Electrical Connection for replacement
new MOTOR, model oven:
- Synthesis 05/40 e 08/45;
Features techniques Motors, 230V-50Hz
e 230V-60Hz.

DESCRIPTION/DESCRIZIONE
Synthesis 05/40-Collegamento
per sostituzione motore vent.

DRAFTED/DISEGNATO	DATE/DATE	SCALE/SCALA	CODE/CODICE	SHEET/FOGLIO	APPROVED/APPROVATO	DATE/DATE
Soave	19/11/2009	- -	IMPI0150	1/1	Farina Simone	18/05/2011

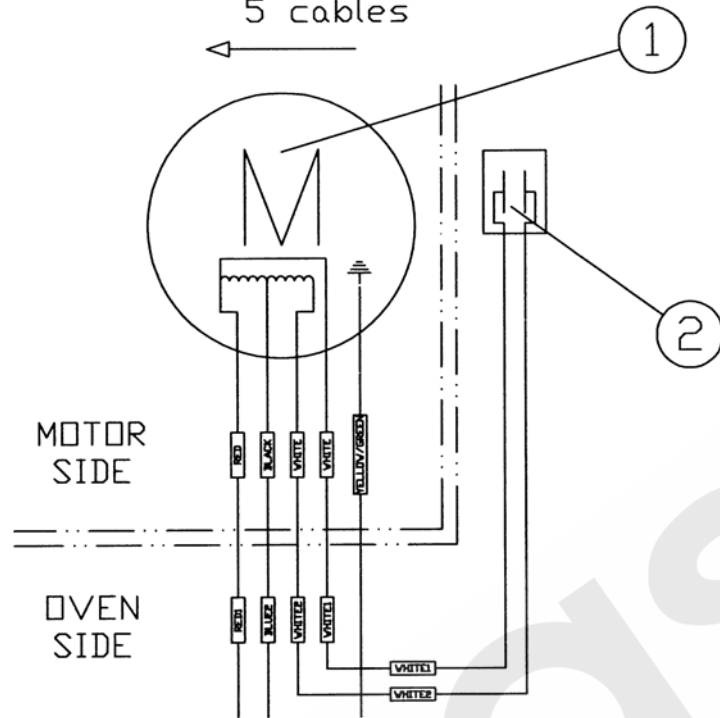
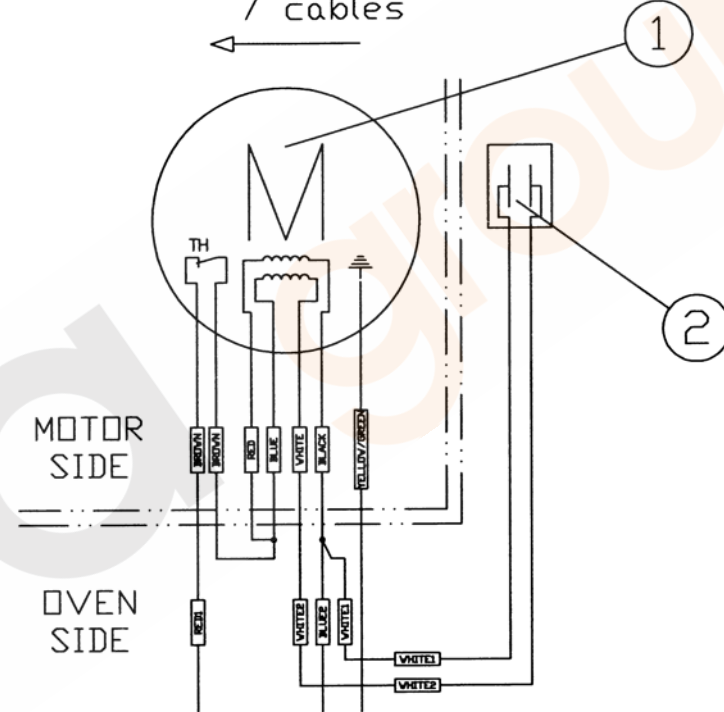
Old electric motor,
without thermal sensor

5 cables

New electric motor,
with thermal sensor

7 cables
